**SUBJECT: EPRI Topical Report TR-112657 Revision B-A, Revised Risk-Informed Inservice Inspection Procedure. Reference Project #669.**

# **Revised Risk-Informed Inservice Inspection Evaluation Procedure (PWRMRP-05)**

**TR-112657 Rev. B-A**

**SAFETY EVALUATION REPORT RELATED TO  
"REVISED RISK-INFORMED INSERVICE INSPECTION EVALUATION PROCEDURE"  
(EPRI TR-112657, Rev. B, JULY 1999)**

**Figure 3-6**  
Decision Criteria for Evaluating RI-ISI Impacts on CDF and LERF

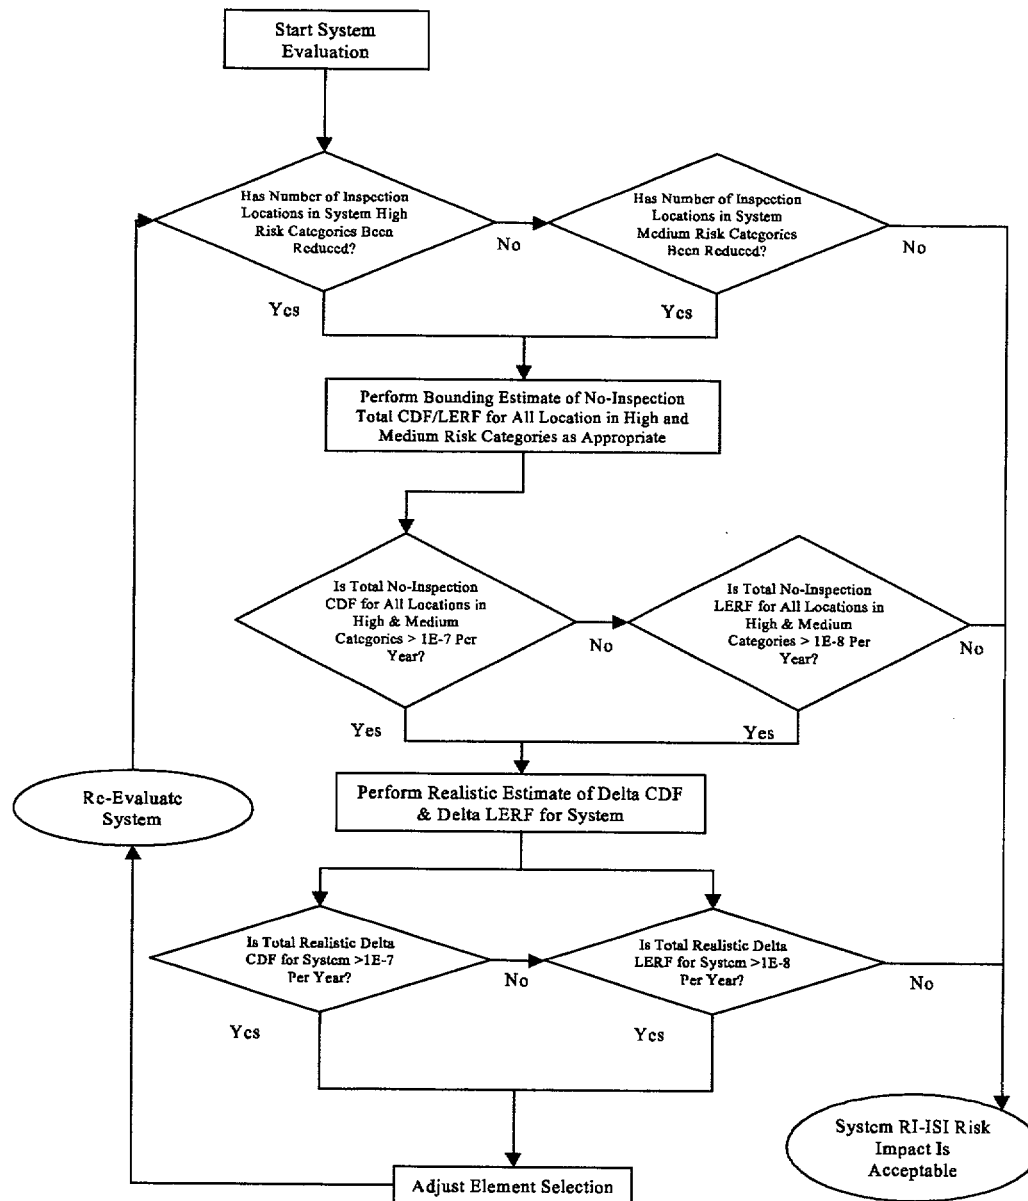
For more extensive changes in the number of inspections in the High- and Medium-risk category welds, a quantitative estimate of the change in risk should be developed. The EPRI TR includes a flowchart in Figure 3-6 that outlines the decision criteria for evaluating RI-ISI impacts on CDF and LERF. The staff finds that this flowchart contains the appropriate steps in the correct sequence to guide the estimation of risk process and to determine what level of effort is required on the basis of the specific results of each licensee's evaluation. The bounding calculation methodology using both no POD increase and a POD increase was reviewed by the staff during the pilot applications and found to be acceptable for investigating the change in risk associated with changing the number and the locations of welds to be inspected as part of an RI-ISI application that uses the EPRI methodology.
